Site Plan Case SP-2021-2-Rev1

Mainstreet Chrysler Dodge Jeep Ram – Paint Shop

211 Plaza Dr. (Directly West of the Dealership)

sheet number: **A1.1**  
 drawing type: permit  
 project number: 21148

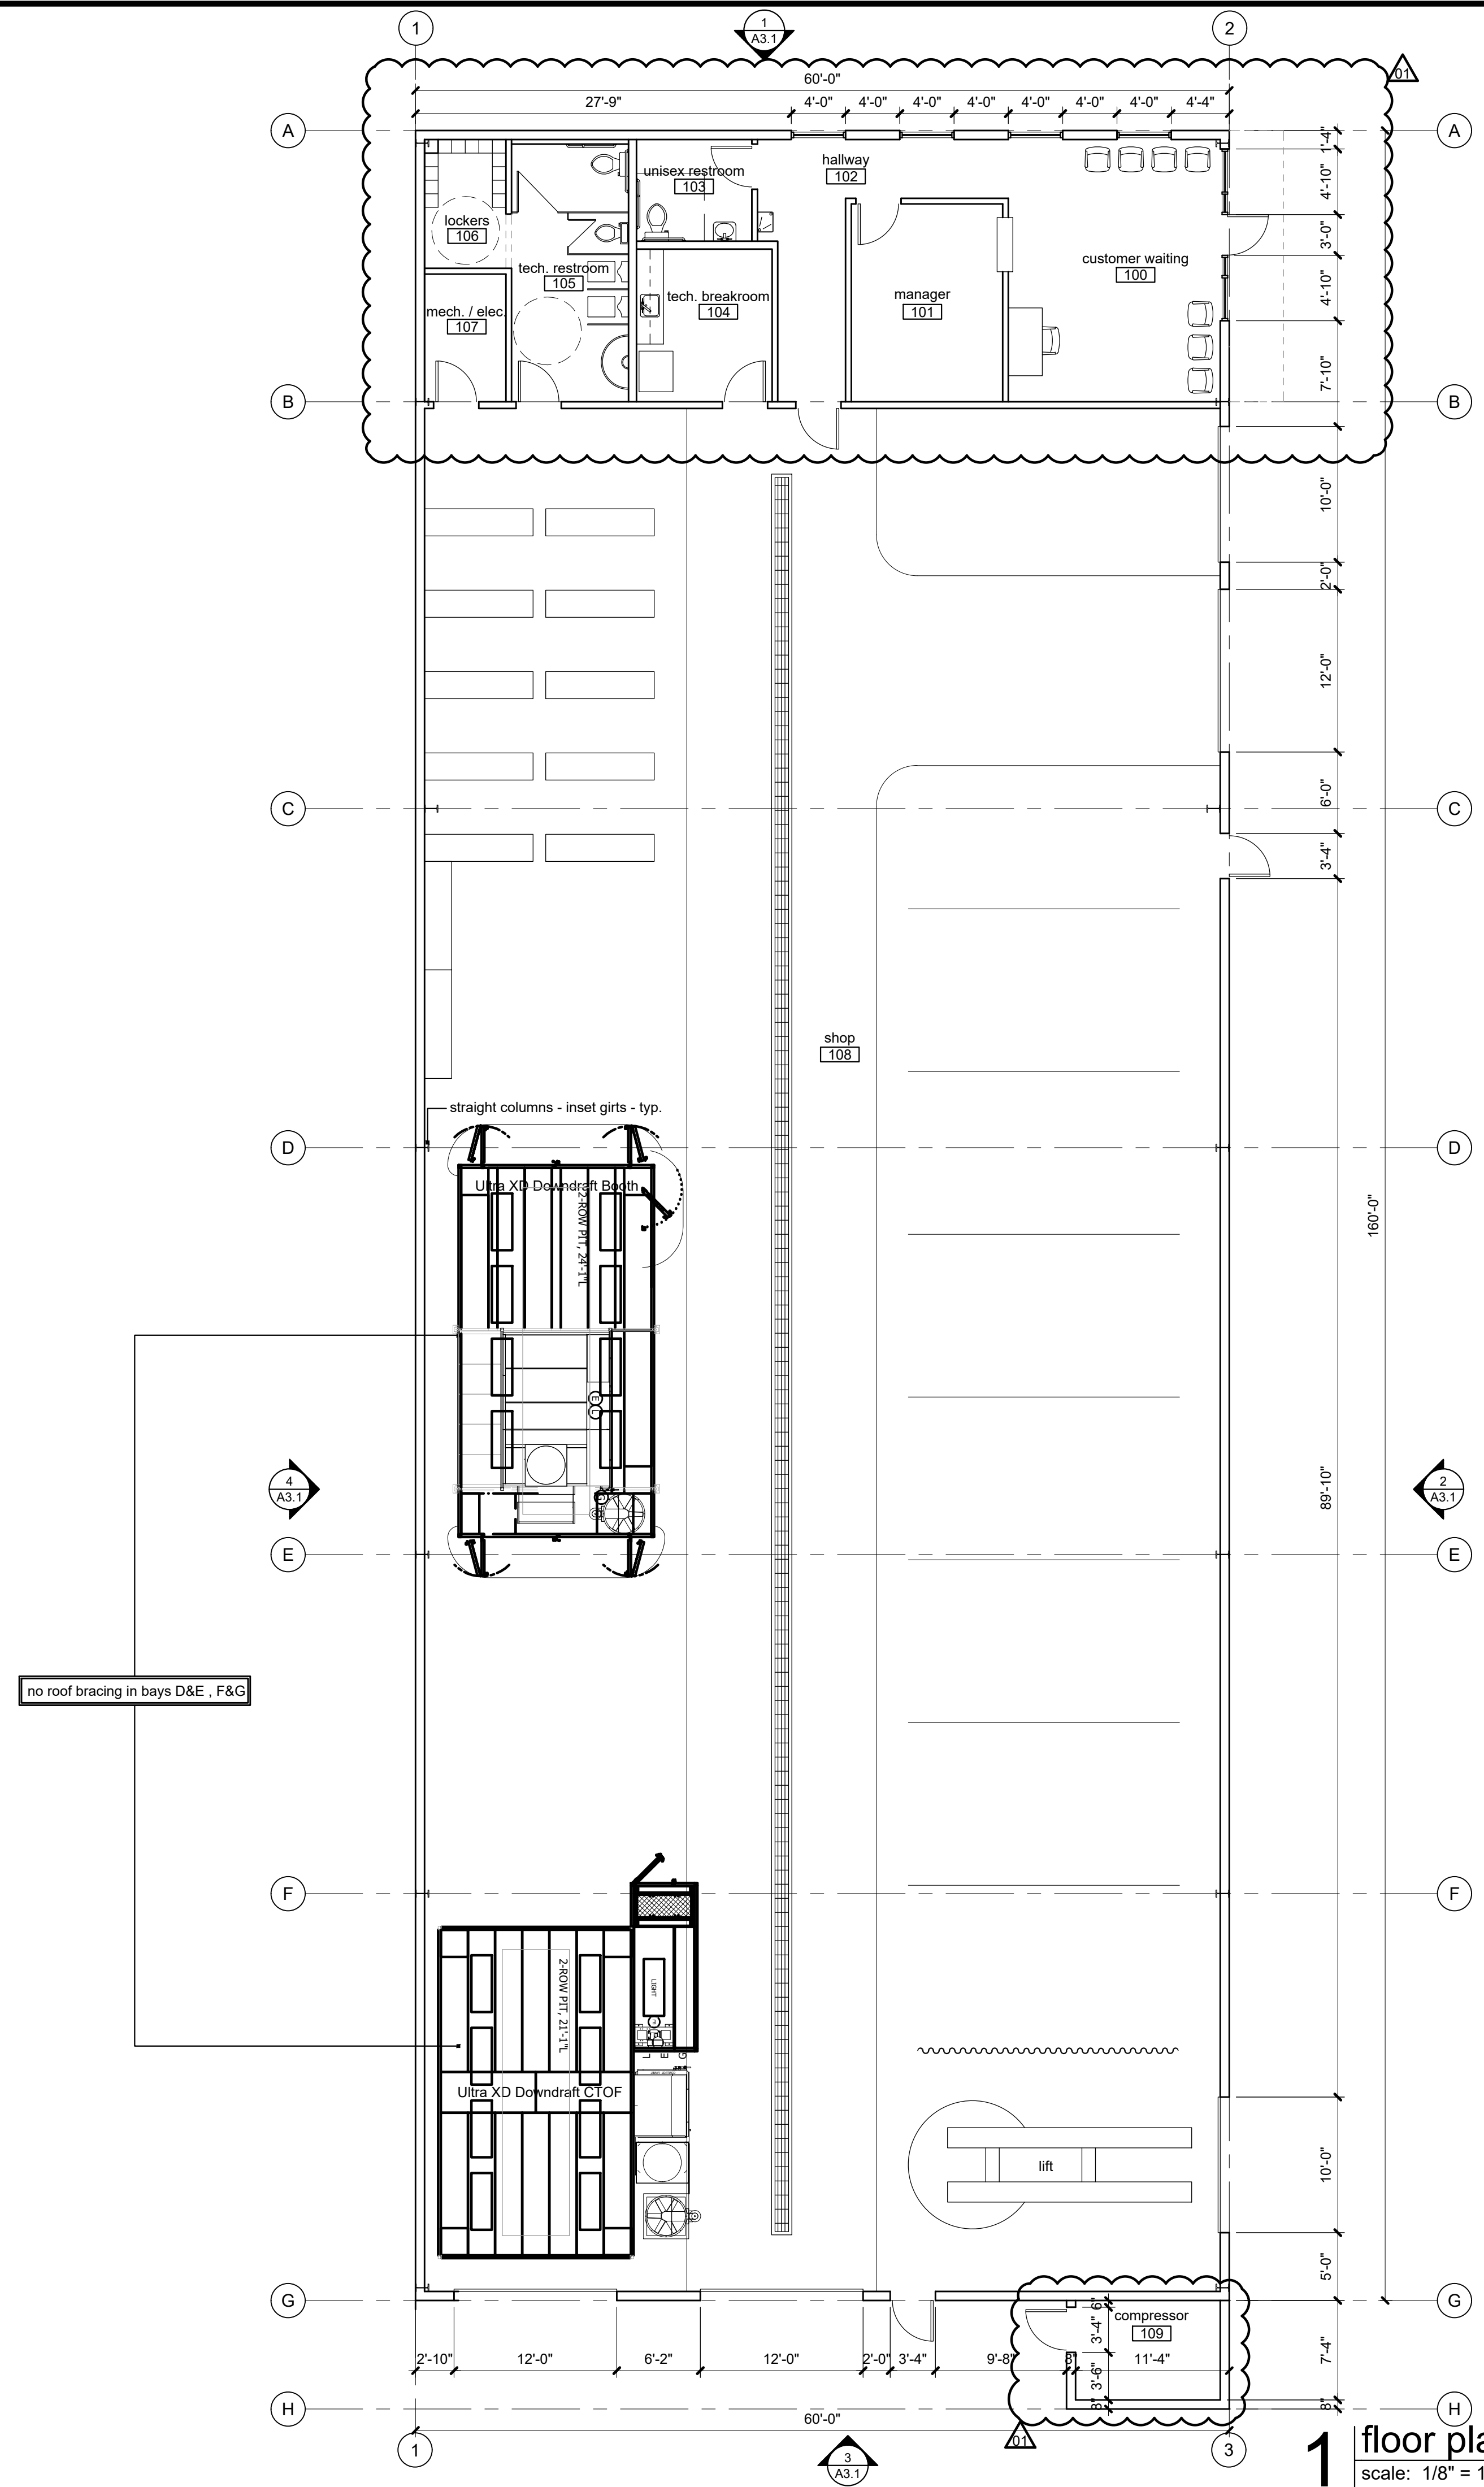
1. In general, any site plan in compliance with all requirements of this code shall be approved.
  - *The existing structure is a Nonconforming Structure Per Section 4.02, Table 4-1 General Development Standards, and will be removed. **The plans as drawn are not set back 10 feet from the residential district which is allowed due to a variance request approved by the Board of Zoning Appeals on January 5<sup>th</sup>, 2022, reducing the western edge setback on the property to 6' which is what the original building was.***

- *Because the variance was approved by the Board of Zoning Appeals, the proposed development does fit on the site as designed.*
  - The design and arrangement of buildings and open spaces is consistent with good planning, landscape design, and site engineering principles and practices.

The site plan does not show the current zoning, but the site is zoned as B-3 – Regional Business District per the Lansing Zoning Map.

There is no trash enclosure shown on the proposed development. It is assumed that any needed trash services for the property will either be handled within the building or will utilize the next-door property owned by the same owner.

**The Director has worked with Leavenworth County Fire District #1 to obtain approval for the project. The Fire Department has agreed that installing pavement markings on the property to ensure that a fire lane always exists is adequate for this development.**

sheet number: **A3.1**  
 drawing type: permit  
 project number: 21148

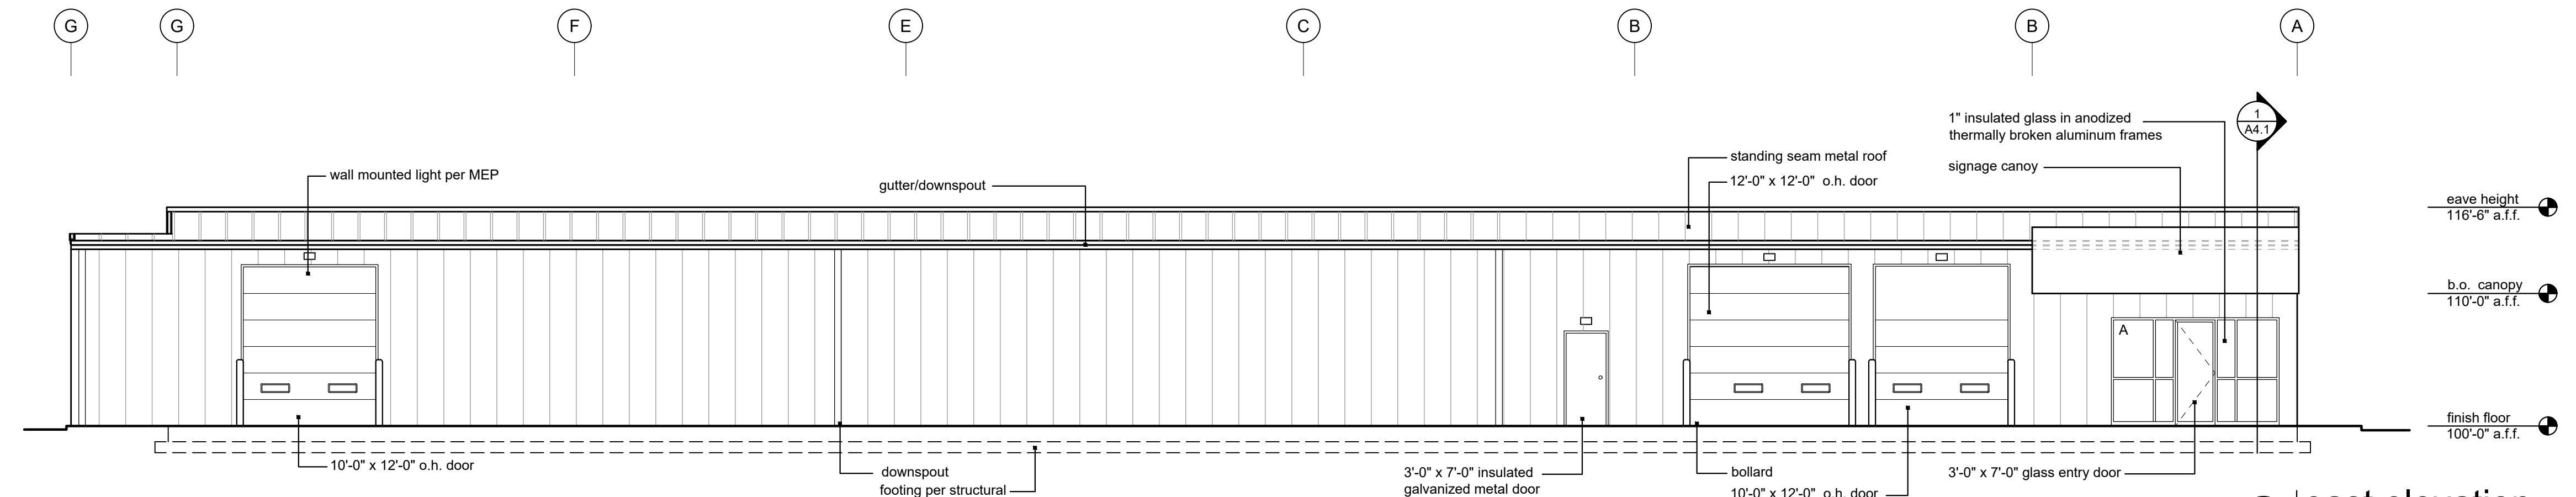
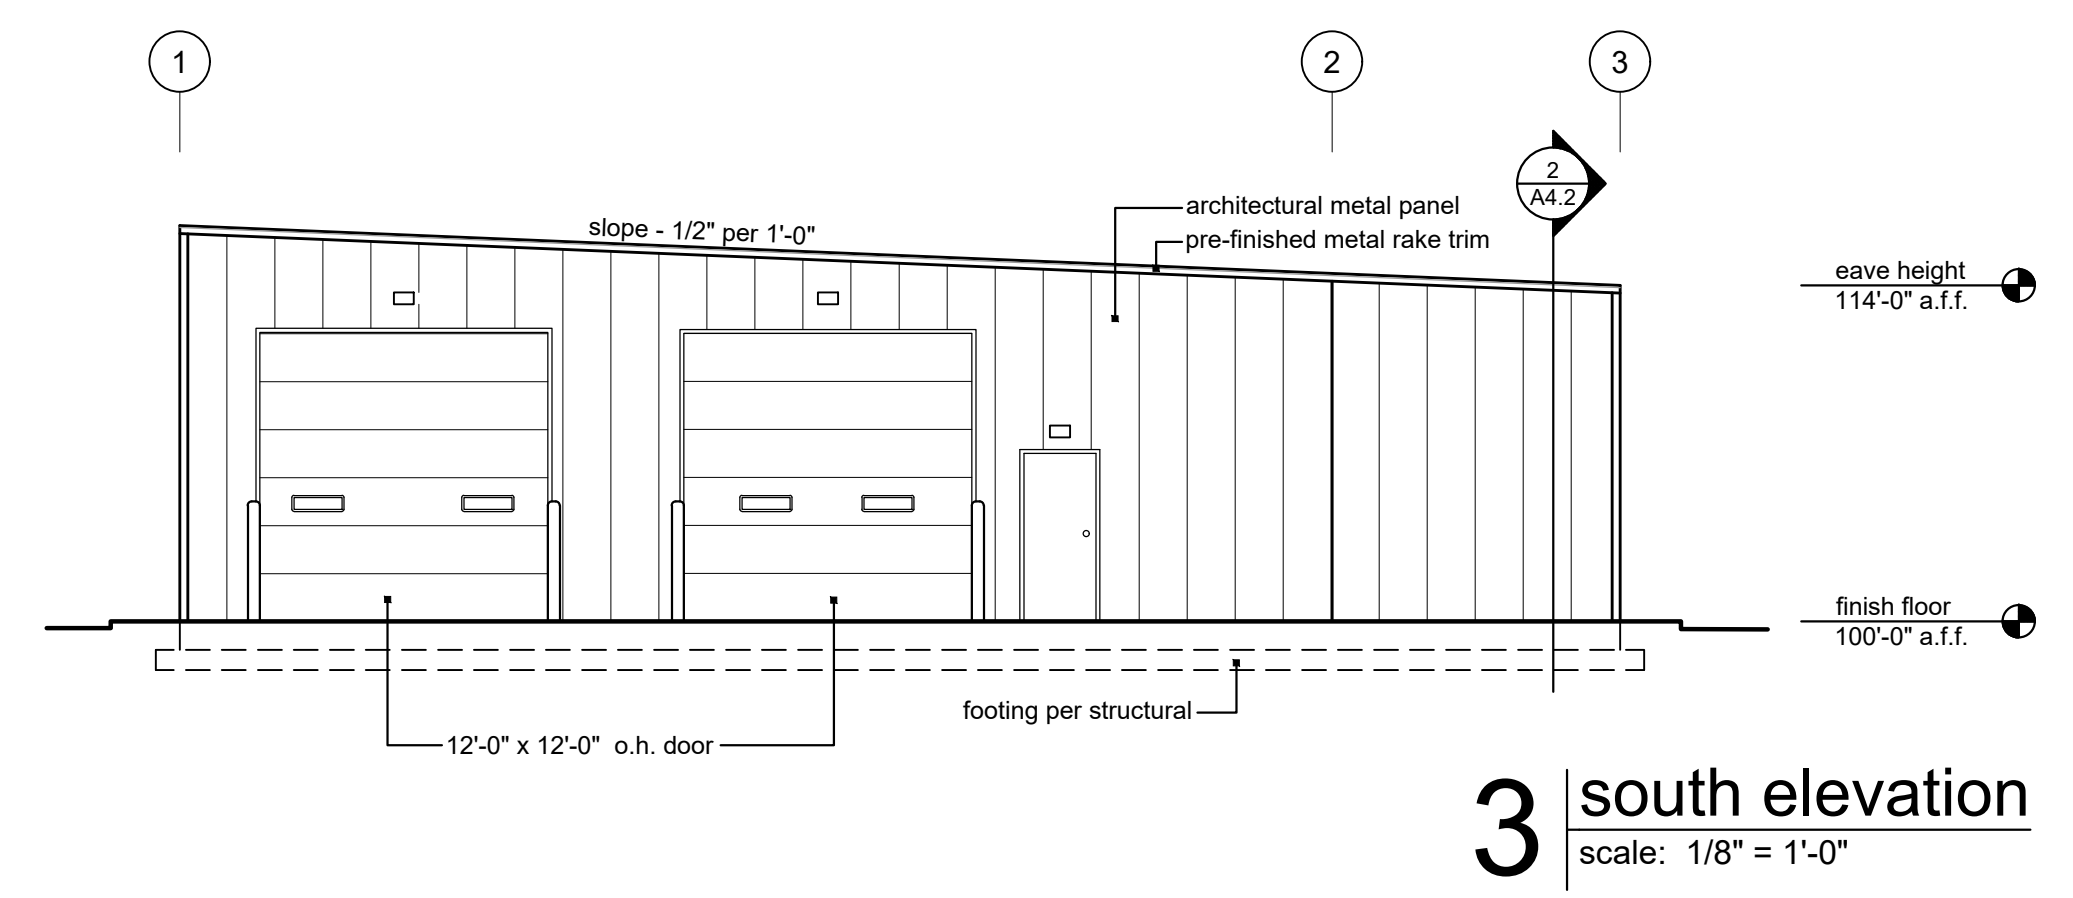
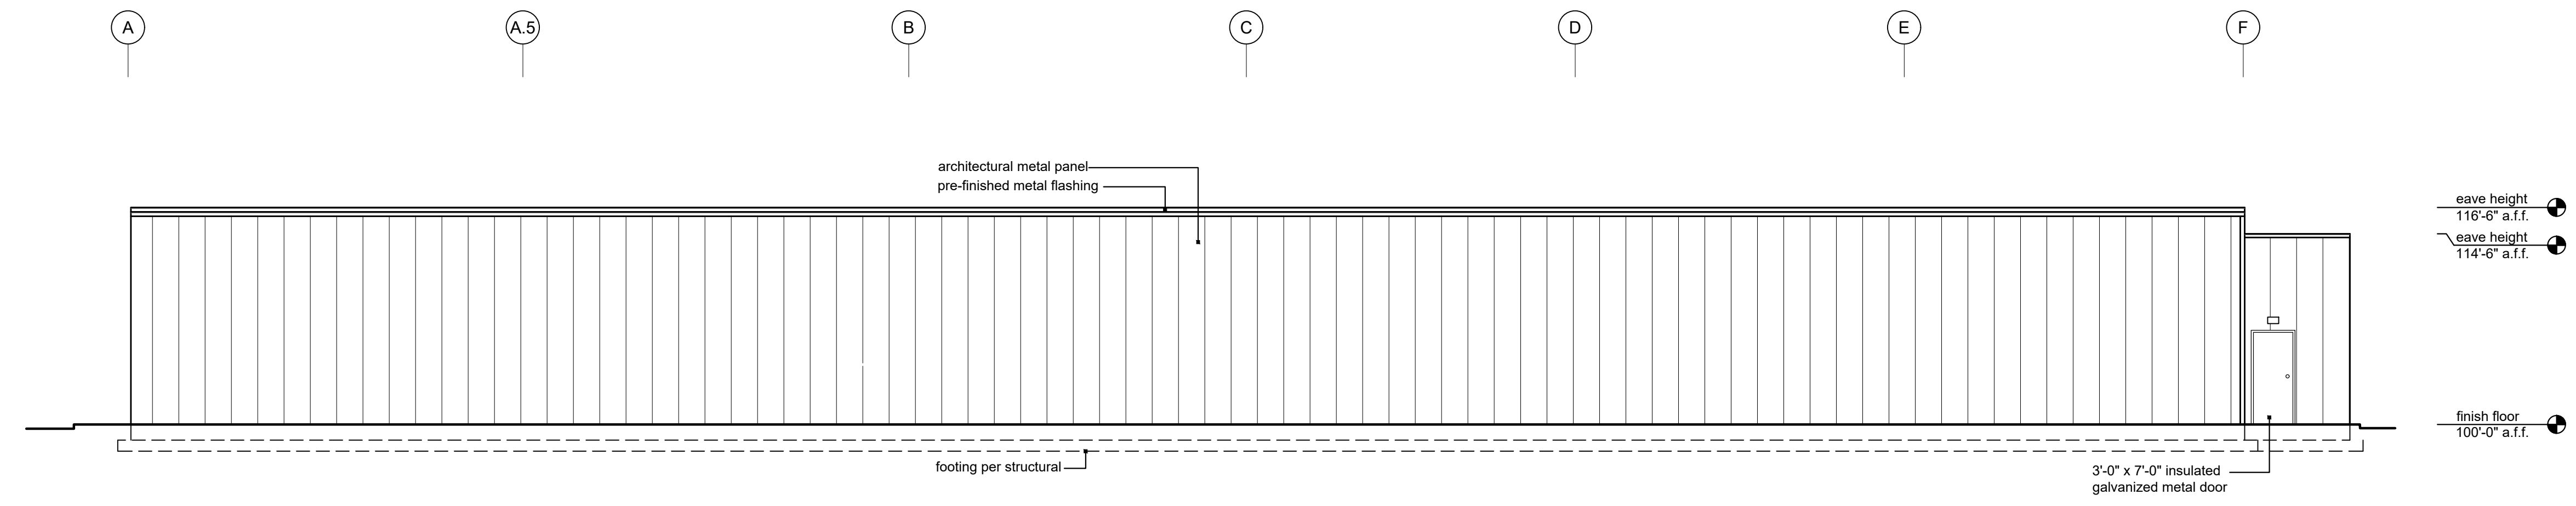
- *The new building is proposed to be made of architectural metal panels and pre-finished metal rake trim, consistent with the existing building and the neighboring building to the east. The proposed architectural style and building materials appear to be appropriate for the site, which is in B-3 – Regional Business District along K-7.*
